Washington State Convention Center Addition Project: Co-Development

Design Review Board Recommendation Meeting 02
01-16-2018

DRB#1 CONDITION OF APPROVAL RESPONSE

SITE C: HOWELL STREET - MIDDLE GLASS BAY

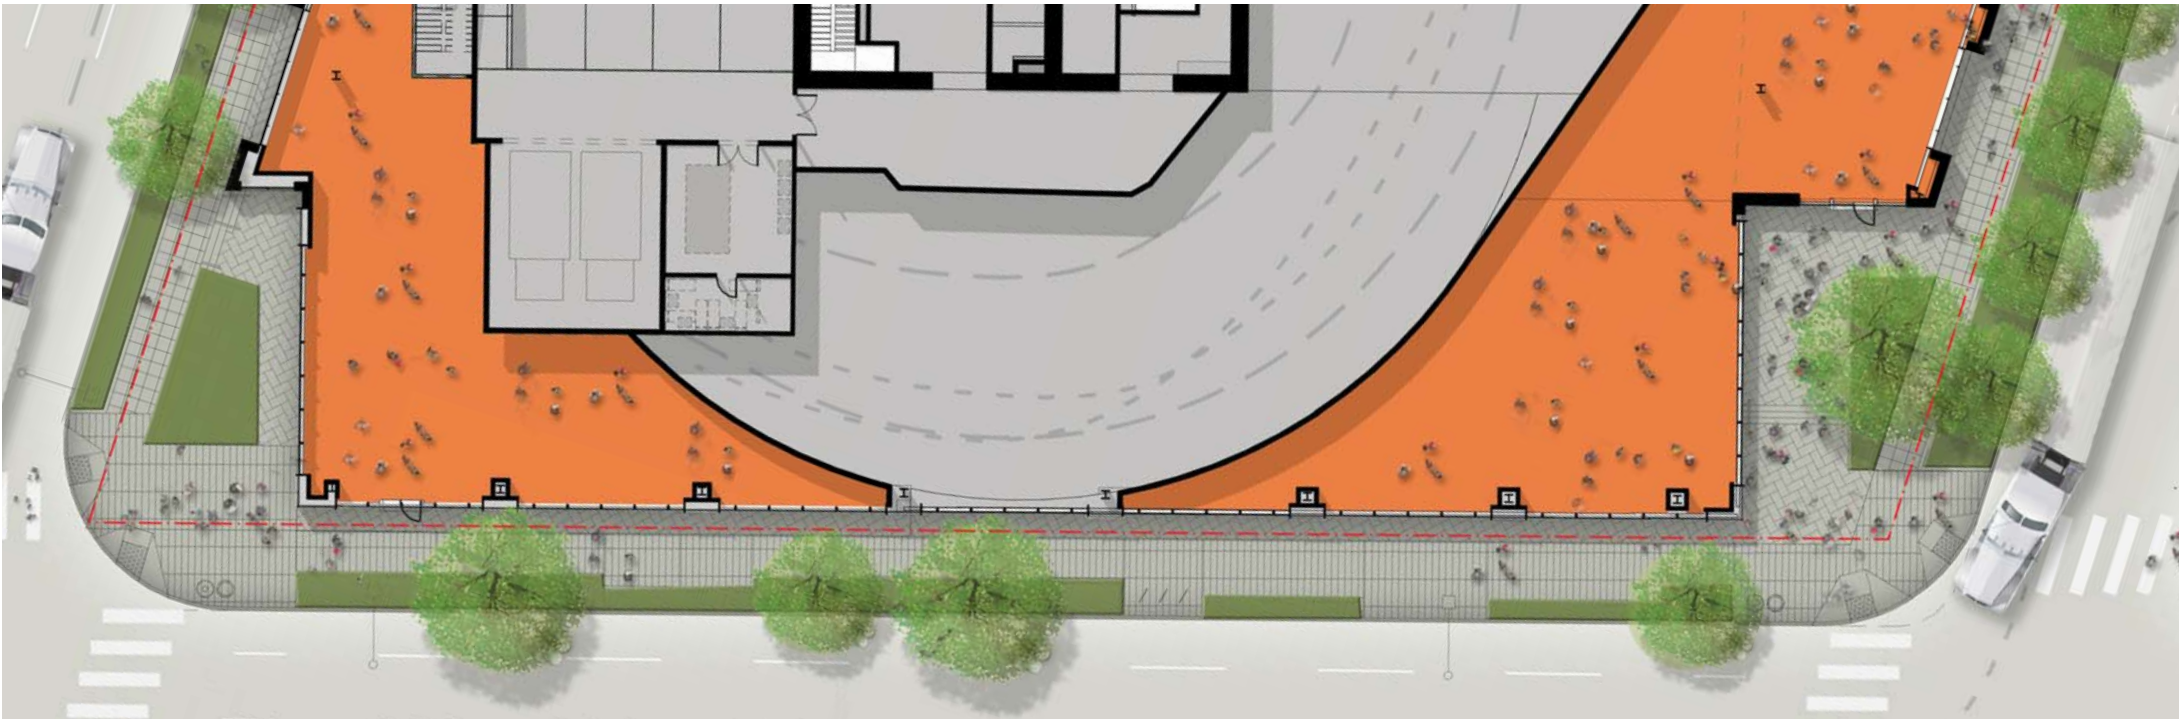
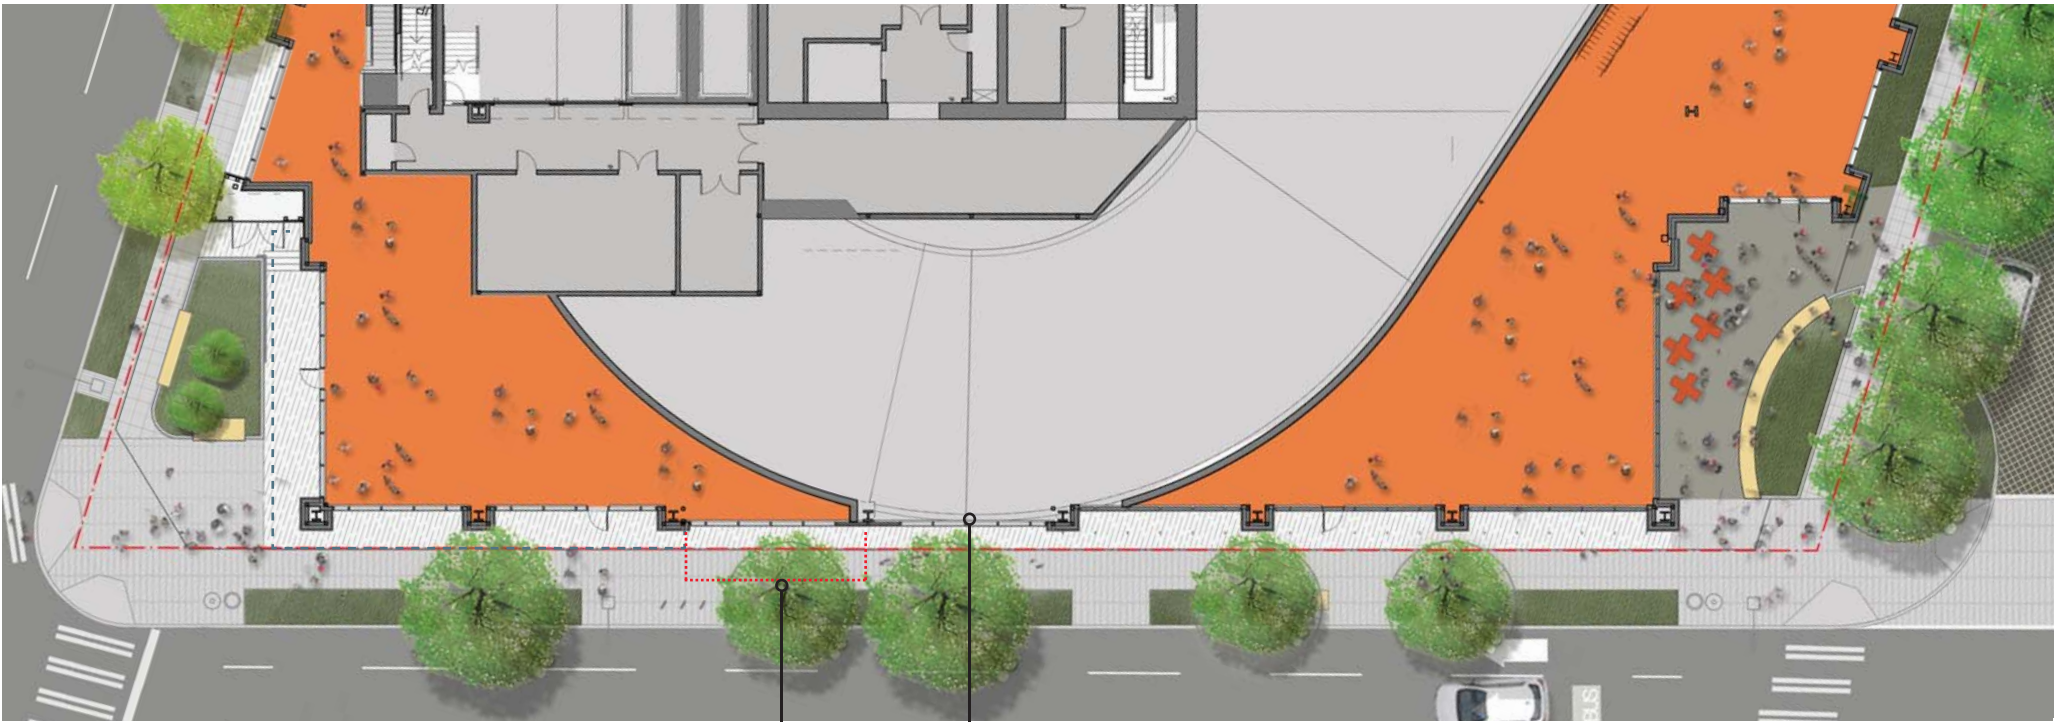
Revise the middle bay glass into the loading ramp on Howell Street [91/middle] be about 50% clear with frit or patterns at pedestrian eye-level; revise the upper metal panel/louvers between the black piers [97] to a darker tone, but not matching the stone; revise and strengthen the edges of the southwest entry volume. (C2) 12)

The middle glass bay looking into the loading ramp along Howell St. will have a custom 50% glass frit, designed by an artist. See sheet G312 and G322 in MUP (Office Tower). SDC requested artist-designed frit as a vacation condition. The artist has the option to extend the frit design east another bay if desired by artist and future retail tenant.

SITE C: OLIVE WAY

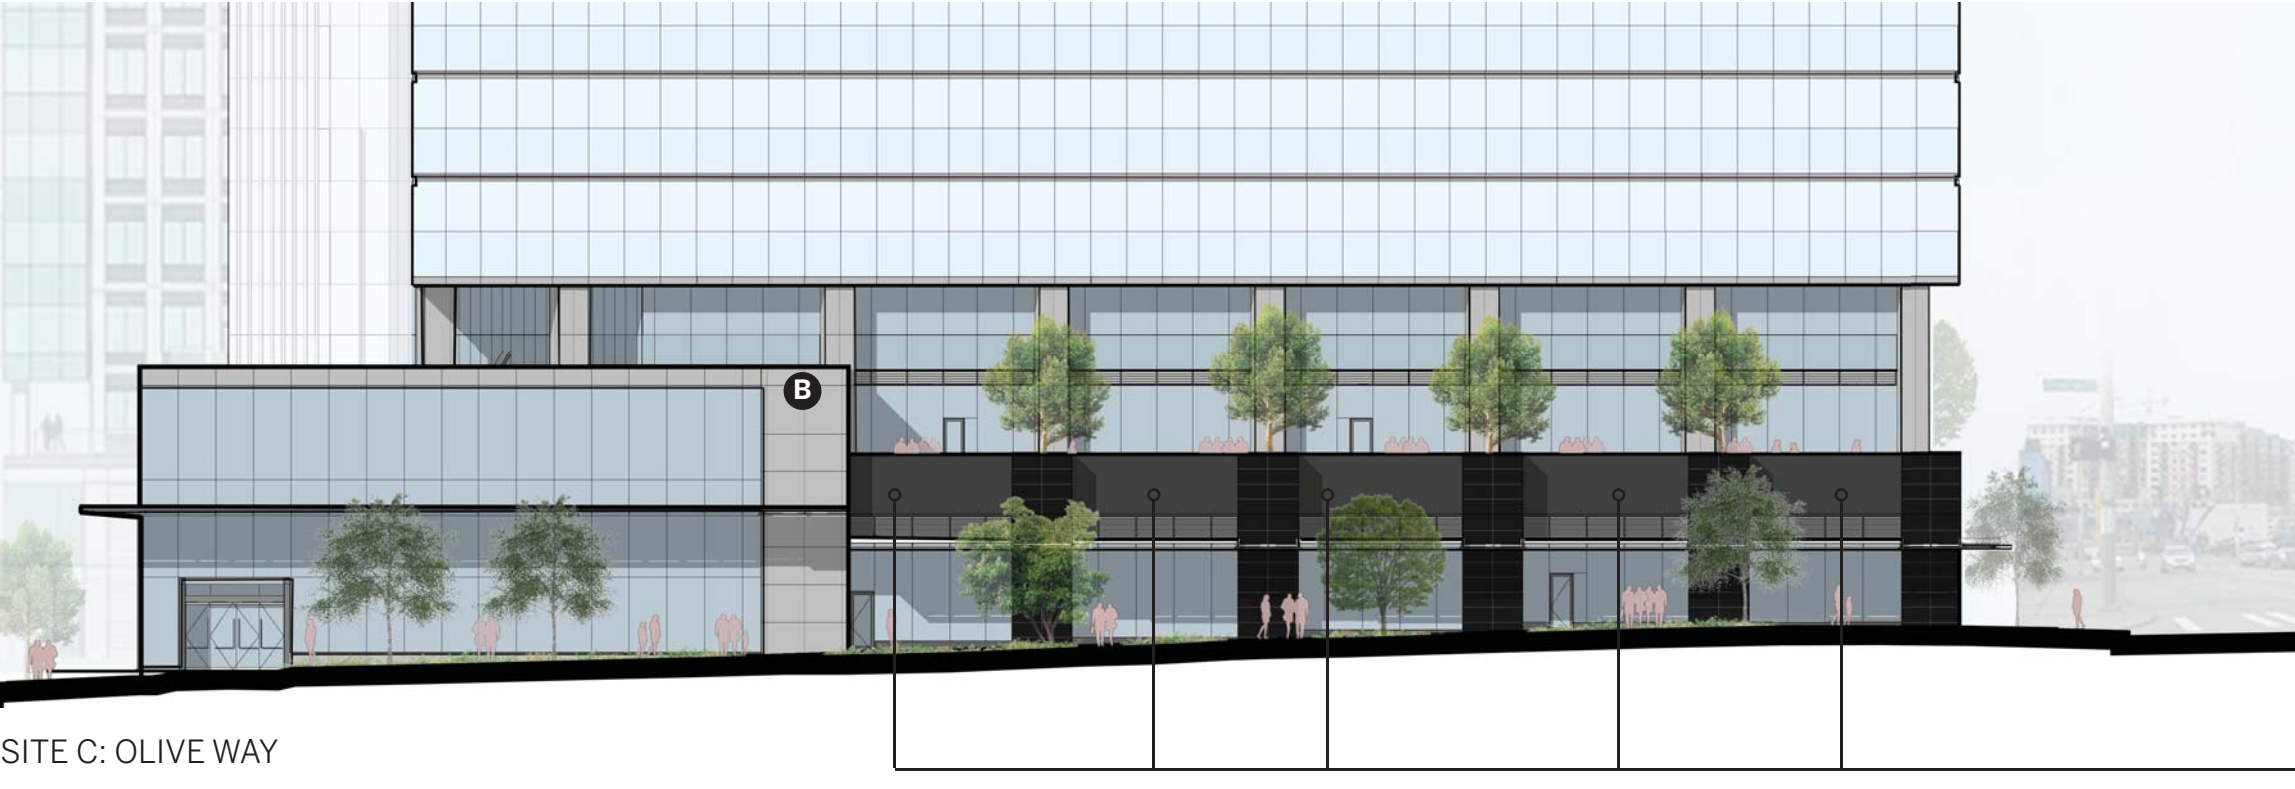
Revise the middle bay glass into the loading ramp on Howell Street [91/middle] to be about 50% clear with frit or patterns at pedestrian eye-level; **revise the upper metal panel/louvers between the black piers [97] to a darker tone, but not matching the stone; revise and strengthen the edges of the southwest entry volume. (C2) 12)**

The metal panel/louver areas between the black stone piers along Terry Avenue, Olive Way and Boren Avenue are a darker tone. See sheet G321 and G322 in MUP (Office Tower). The lobby entry box edges have been widened to give it a stronger definition. See sheet G310 and G321 in MUP (Office Tower).

SITE B & SITE C - THREE LOADING DOORS; 2E & 5C;

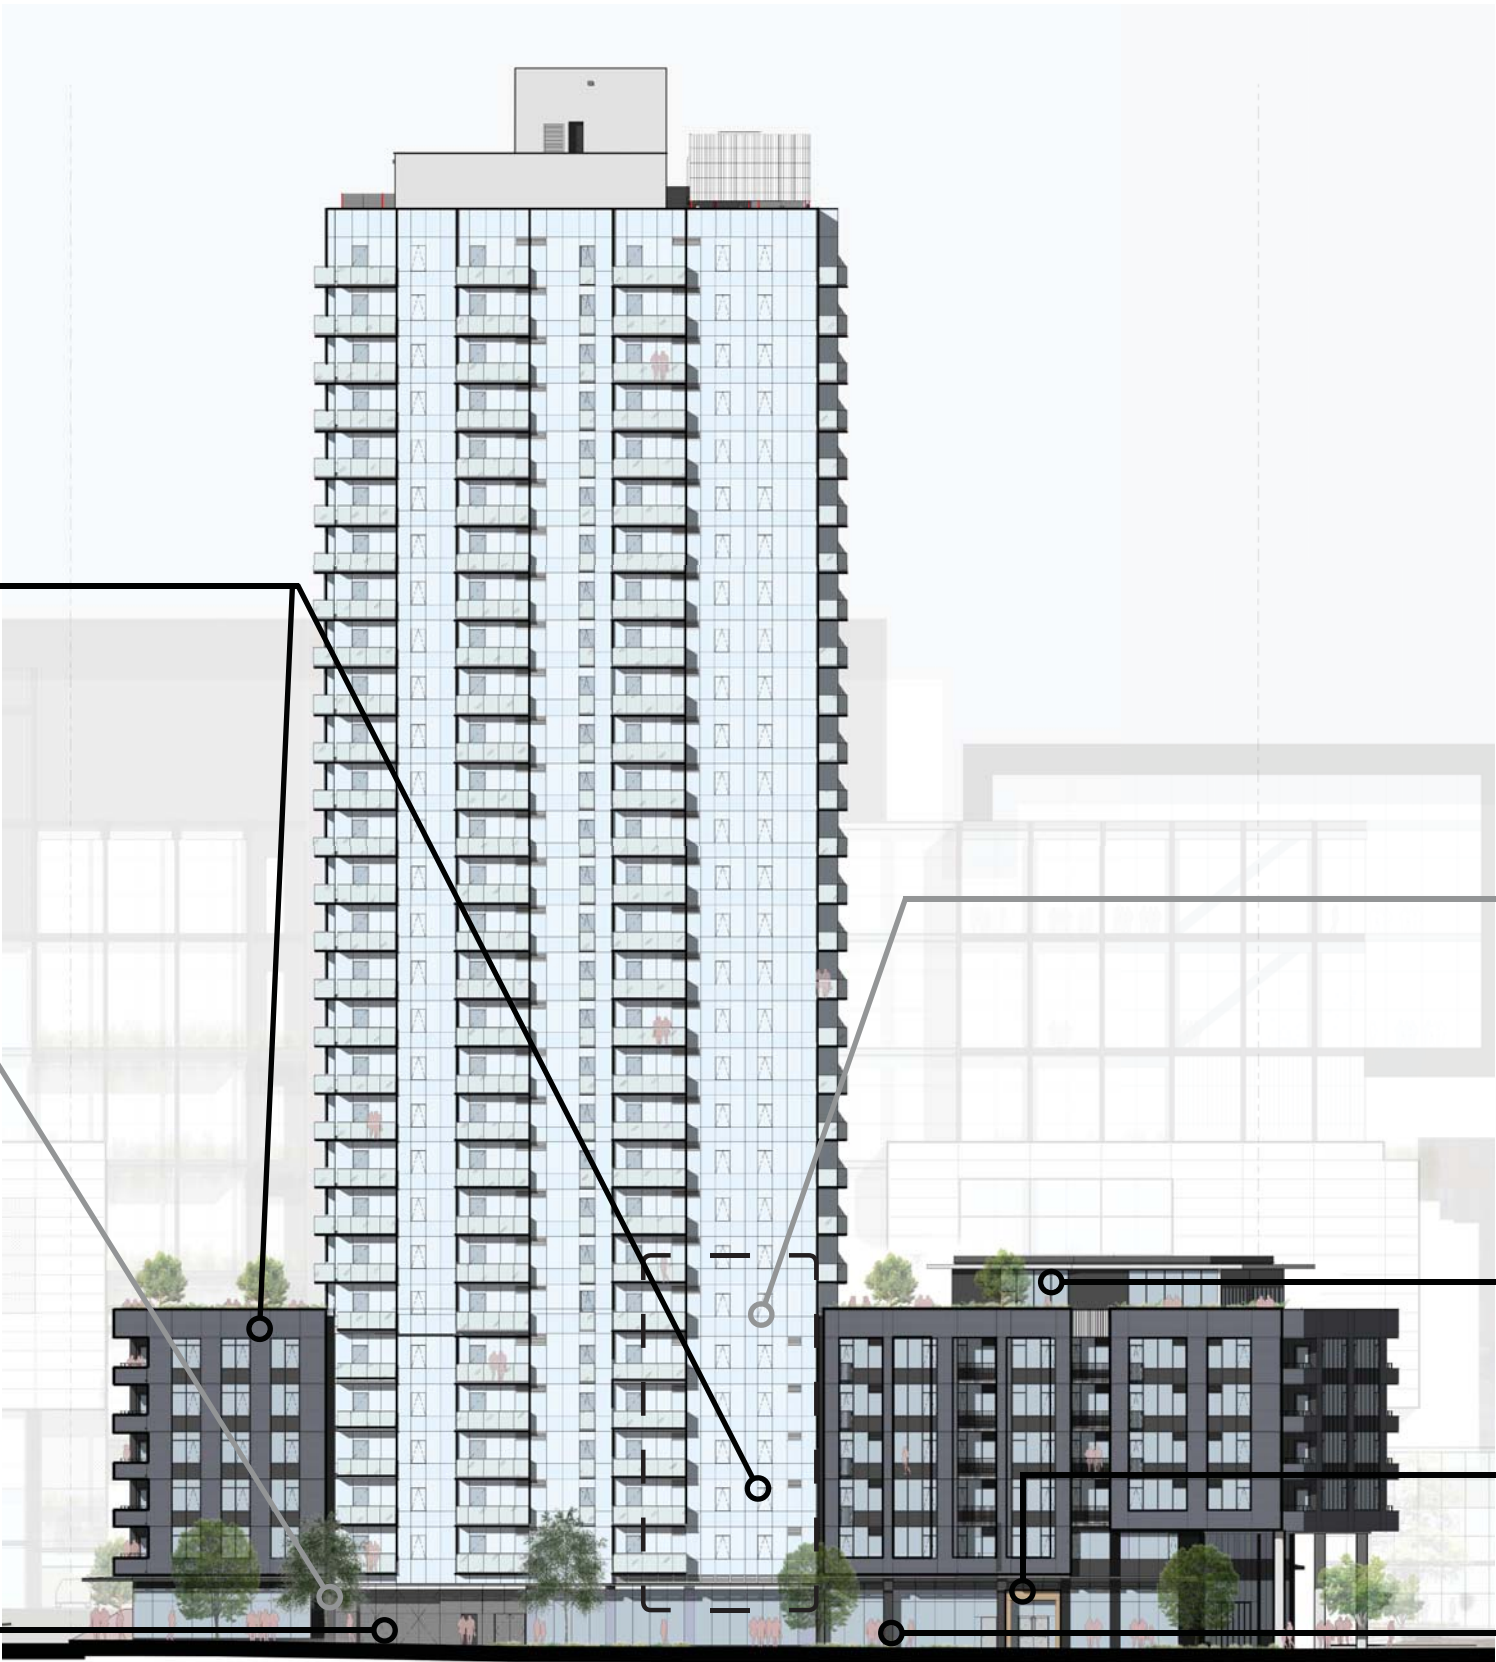
Design the three overhead or sectional doors be include an artful treatment, with high pedestrian visual interest, and/or be translucent glass (the gray door image shown on pg 76 was too generic; the two orange examples shown on pg 43 had more visual interest). (C3, E3)
